REMARKS

In the outstanding official action of November 4, 2002, the examiner has objected to the drawings, objected to claims 8, 10 through 18, 26 through 28 and 32, rejected claims 1 through 10, 19 through 25 and 29 through 37 under 35 U.S.C. §112, rejected claims 1, 2, 19, 20, 30 and 34 under 35 U.S.C. § 102(e) and rejected claims 3 through 10, 21 through 25, 29 and 35 through 37 under 35 U.S.C. § 103(a). Applicants respectfully traverse the stated objections and rejections and submit that in view of the foregoing amendments and the following remarks, this application is now in condition for allowance.

FIG. 1

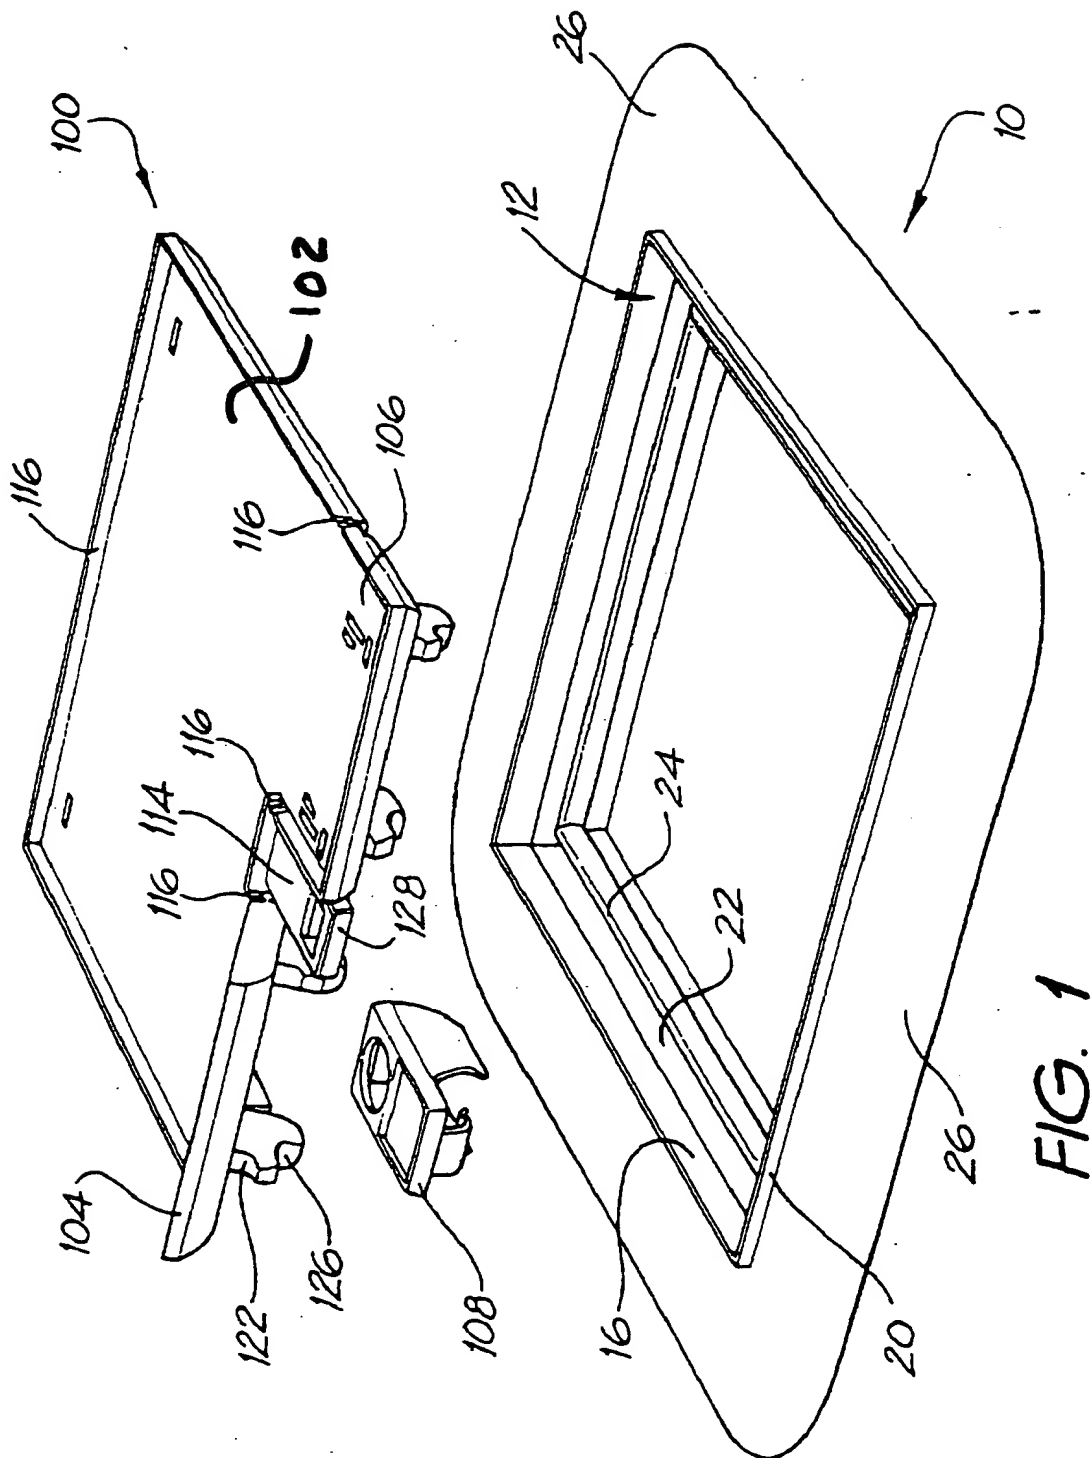
With regard to the objection to the drawings, a marked-up copy of Figure 1 showing an appropriate proposed correction in red adding the reference numeral 102 is attached. In addition, marked-up copies of Figures 2a and 3 are attached showing proposed corrections in

FIG. 2a

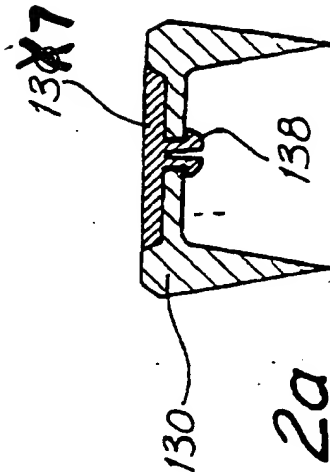
red to correct a couple of minor typographical errors and omissions. It is respectfully requested that the examiner approve the corrections shown in red on the attached marked-up copies.
